CONSULTATION SUMMARY

2022/2090/P

15 Dartmouth Park Avenue
London
NW5 1JL

Proposed lower ground floor rear extension.

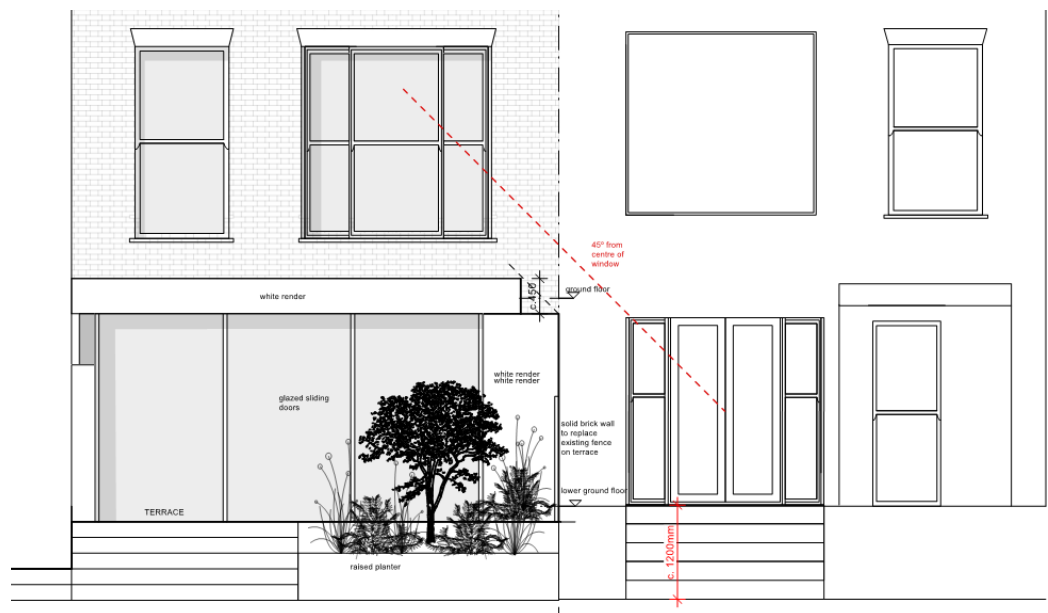
3. Proposed extension would be over 4m in height from level of our patio extending out for 3m. Because there is already a raised patio to the rear of No 11 the effect would be cavernous and overly enclosed. Light will be affected. Request for a Daylight and Sunlight Study if the 45 degree test is failed in regard to No 13's lower ground floor windows.

A 45 degree test is met on elevation, as shown below and therefore the council do not insist on a Daylight and Sunlight study (this is requested when the development fails the 45 degree test on both plan and elevation).
